SDI FINAL EVALUATION FORM 1.1

Journal Name:	Journal of Engineering Research and Reports
Manuscript Number:	Ms_JERR_130296
Title of the Manuscript:	Three New Approaches to estimating Energy Losses in Stepped Spillways with the Channel slope of 8.9o.
Type of Article :	Original Research Article

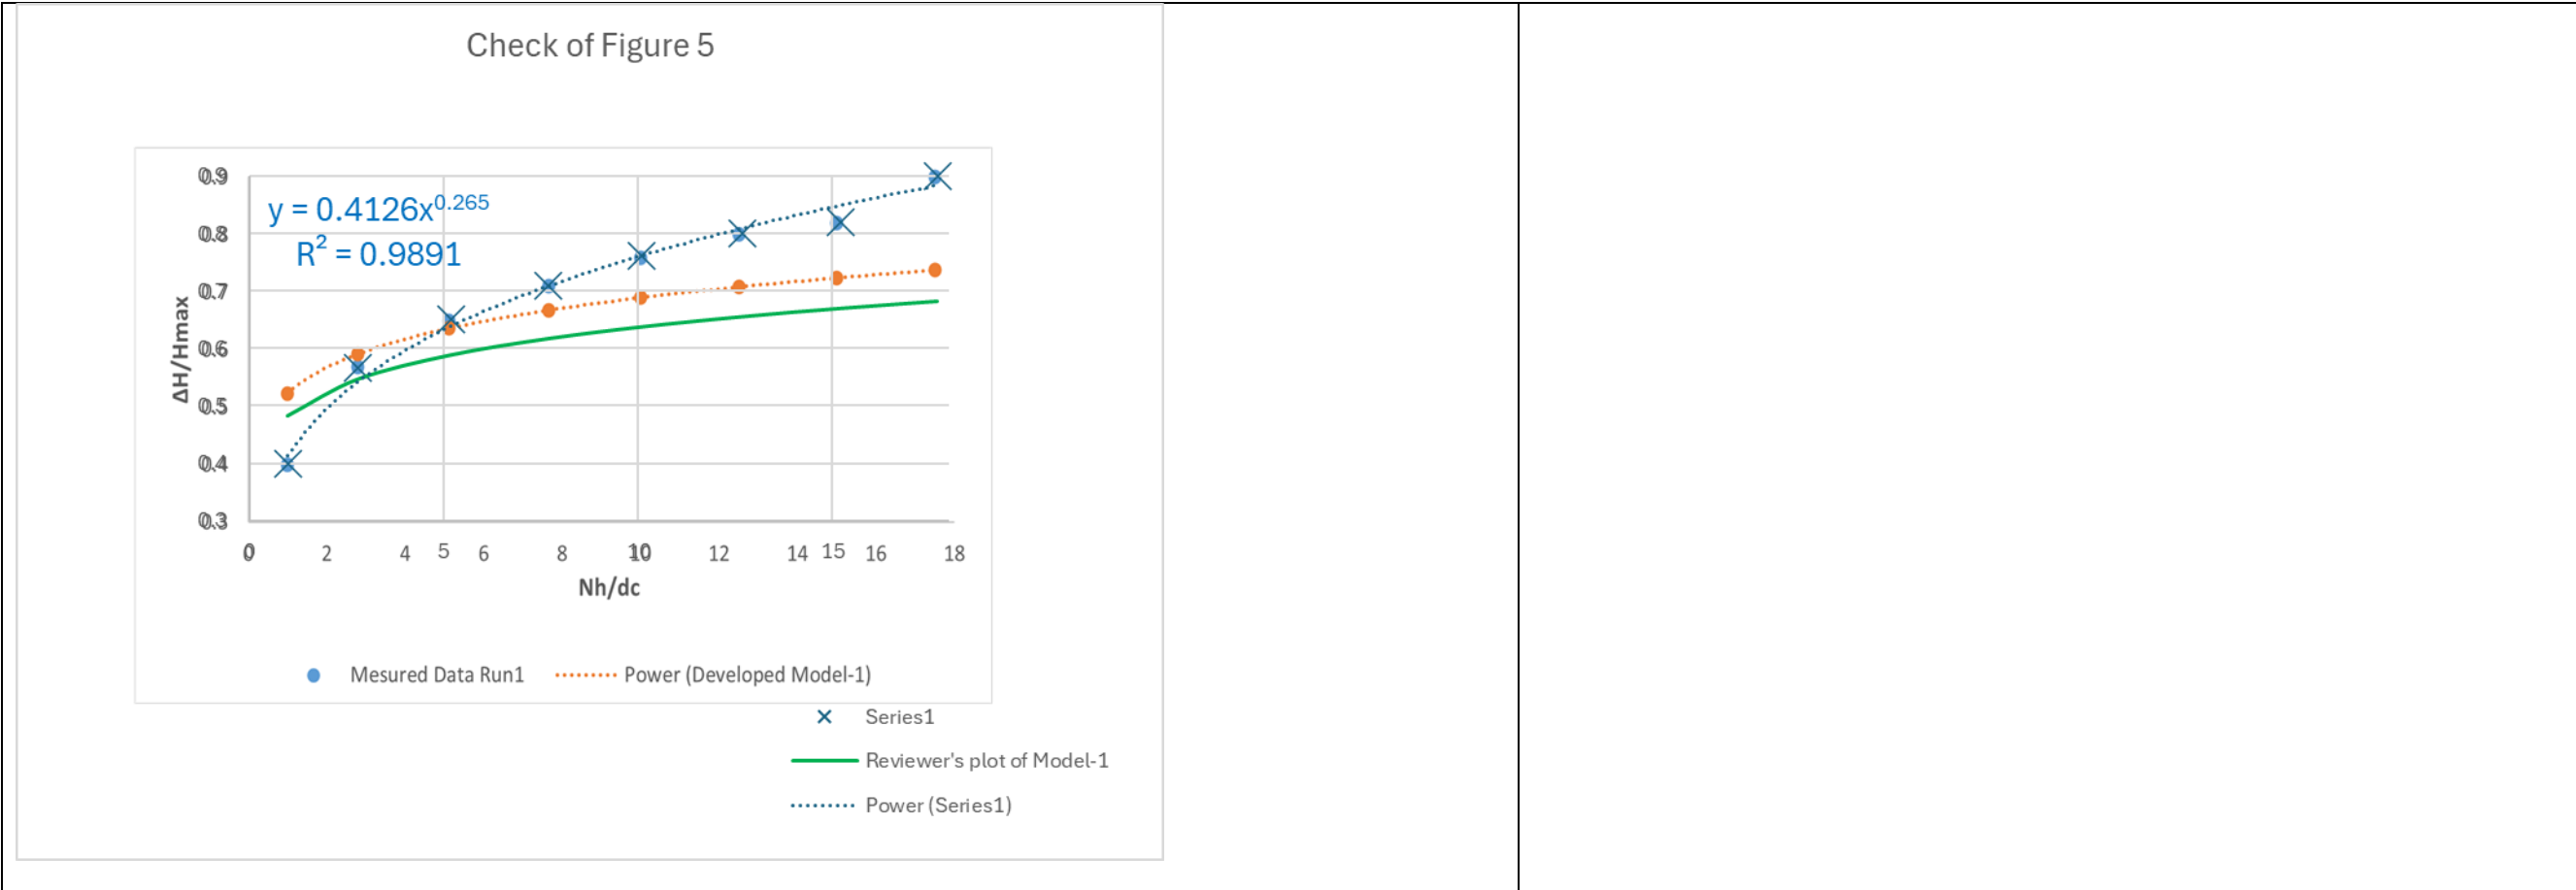
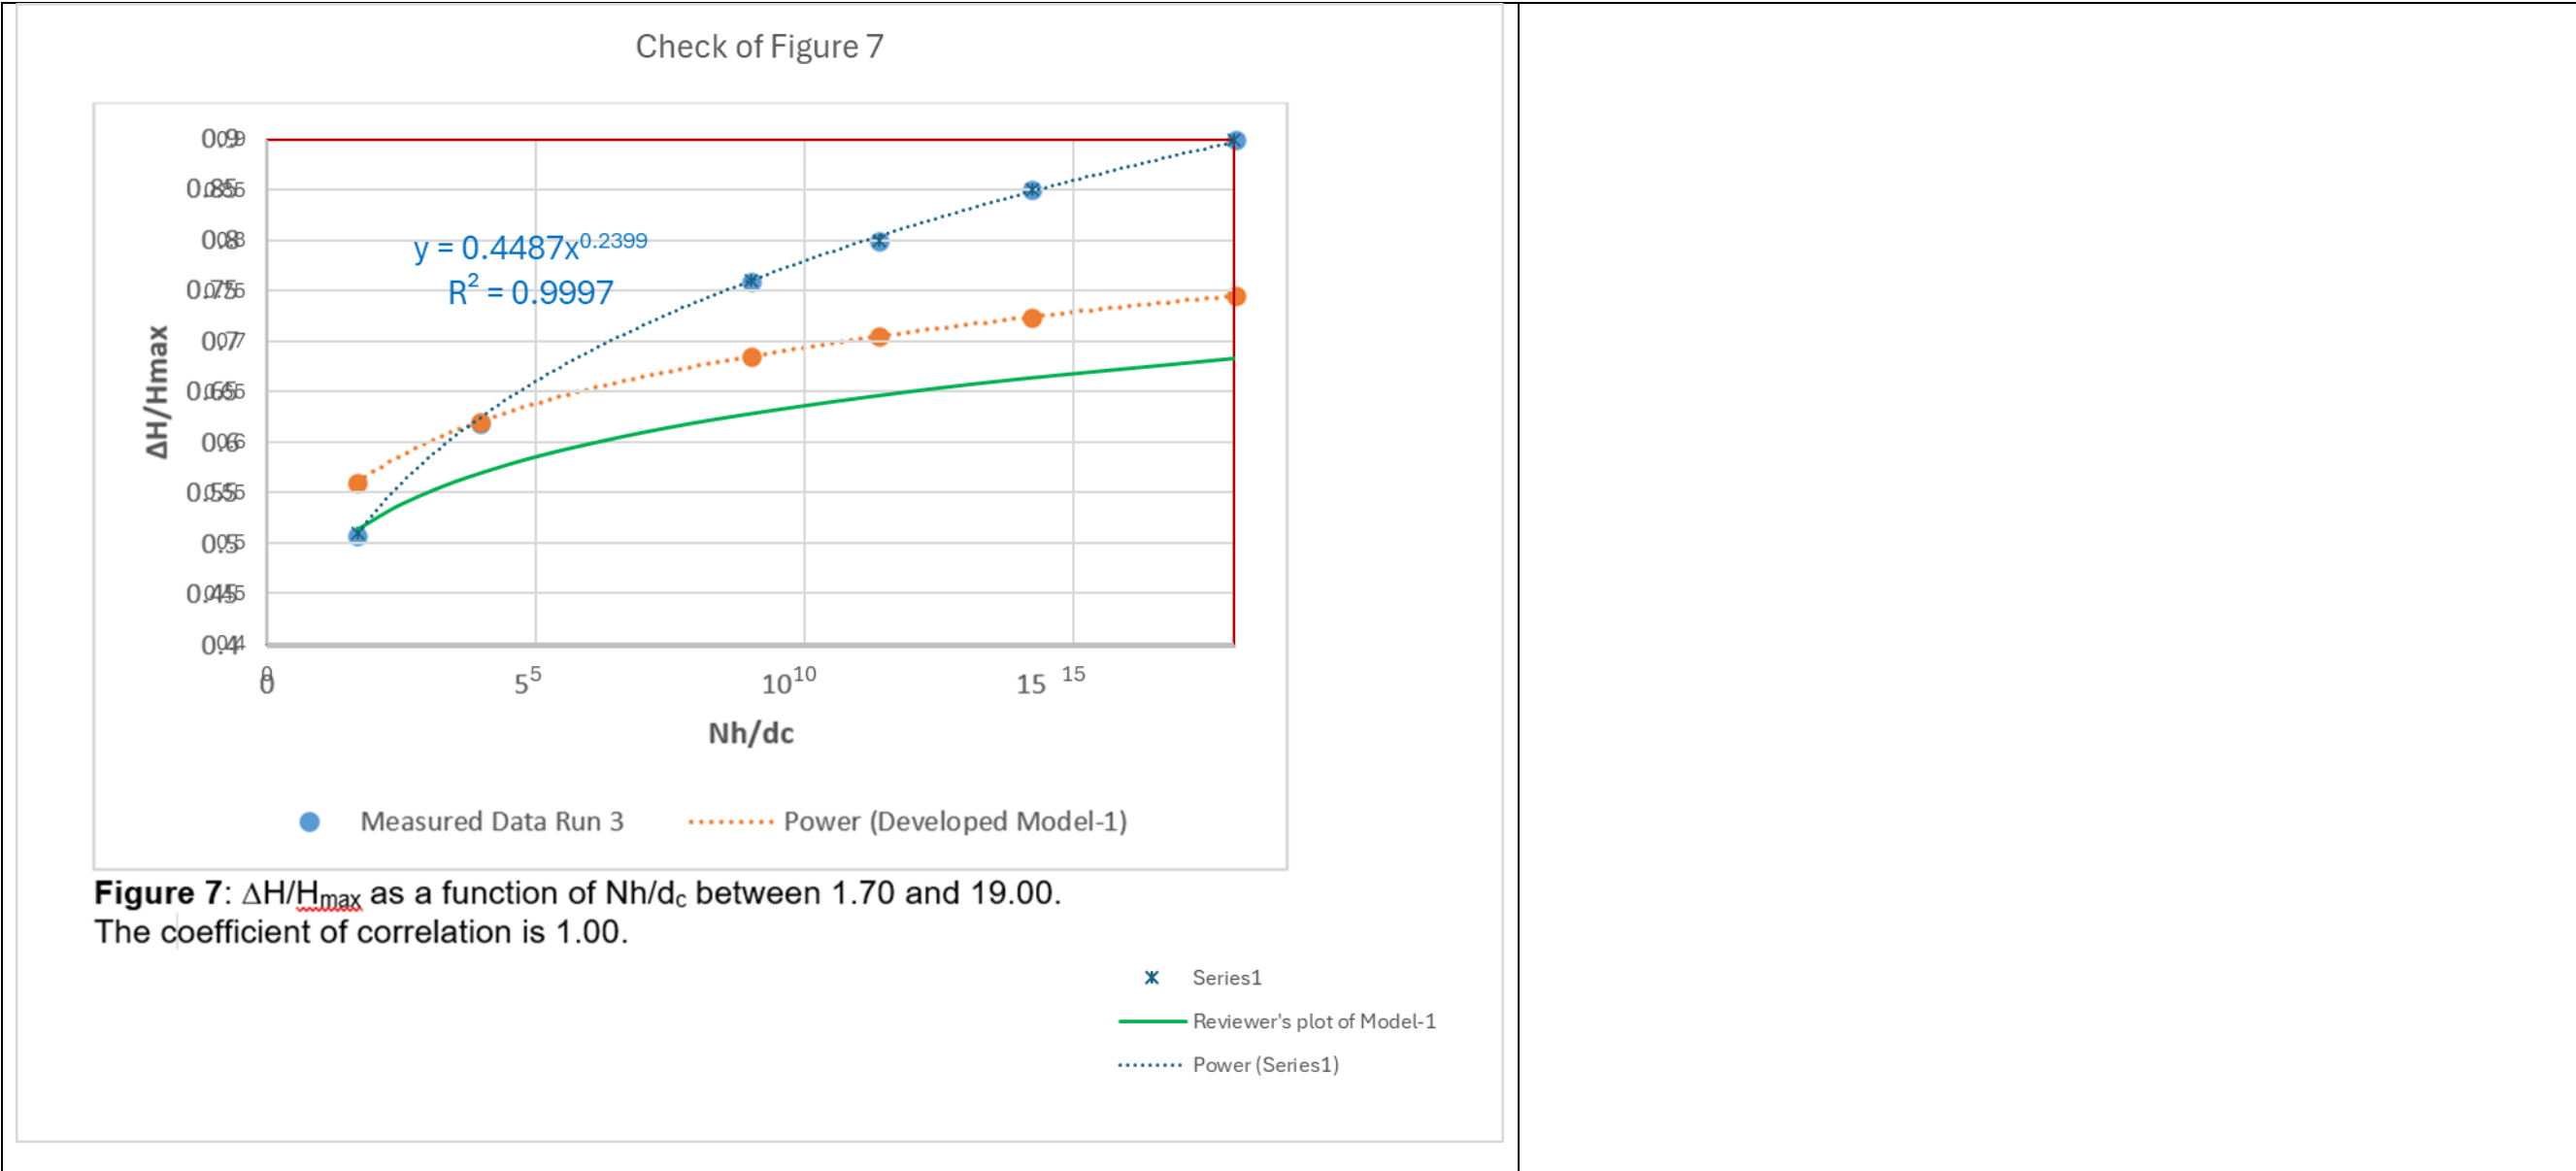
FINAL EVALUATOR’S comments on revised paper (if any)	Authors’ response to final evaluator’s comments
<p>In my first review, my final comment on the Conclusions section was clipped short and apparently did not fully reach the authors. I meant to say:</p> <p>The Conclusions section states:</p> <p>          The results from the developed models, Eq (9) to Eq (11), compare well with the measured data sets (Run 1 to Run 4) in terms of energy dissipation, with the coefficients of correlation that range between 0.95 and 1.0.</p> <p>My comment (which was not included) was:</p> <p>          I disagree strongly with the conclusion. The comparison is relatively poor and I believe the correlation coefficients are calculated incorrectly.</p> <p>.....</p> <p>After reviewing this revision, my opinion is still the same. The authors challenged me to test their curve fits and my observations about the insensitivity of results to various parameters. I find that my original observations were on-target. Model-1 is almost absolutely insensitive to N and h (which is obvious from the fact that the exponents of those terms are nearly zero). Furthermore, N, h, and q are fixed for all data sets, so the models are just functions of (N·h)/d<sub>c</sub>. My previous observation that the fit of the plotted data in the figures does not correspond to the extremely high correlation coefficients (almost equal to 1) is still true. I tried to recreate figures 5, 7, and 9 by overlaying my own plots on theirs and performing my own curve fit. I find that when I use equations 9 and 10 to calculate and plot the model curves (Model-1 and Model-2), they do not match the curves in the authors’ figures. They also do not match the measured data. I also used Excel to generate my own power curve fitted to the measured data and found that reasonable fits can be obtained, but they do not remotely resemble the equations provided in this paper.</p> <p>I still believe that the authors obtained such high correlation coefficients by misusing the Excel trend fitting tools to obtain a trend curve to match their model-computed values. These correlation coefficients do not represent the quality of the fit between measured data and the proposed models.</p> <p>My overlaid plots are shown on the next pages:</p>

Series1   Reviewer's plot of Model-2   Power (Series1)

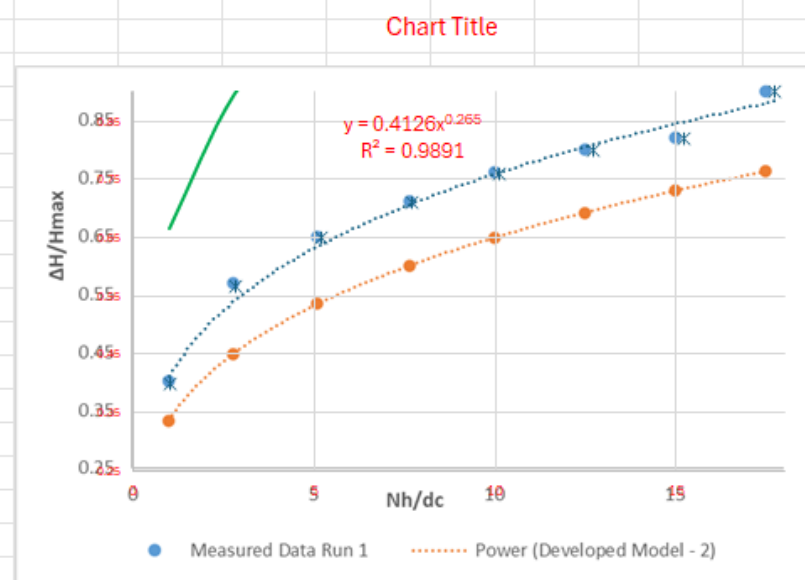
$$\Delta H/H_{\max} = (0.05 N h/d_c)^{0.29} N^{0.20} h^{-0.17} \theta^{-0.30}$$

0.05	0.0046 works much better to match their curve			
0.29				
0.2				
-0.17				
-0.3

**For this plot, changing the 0.05 to 0.0046 produces a better match of the equation to the author's plotted curve, but their curve still does not match the observed data.**
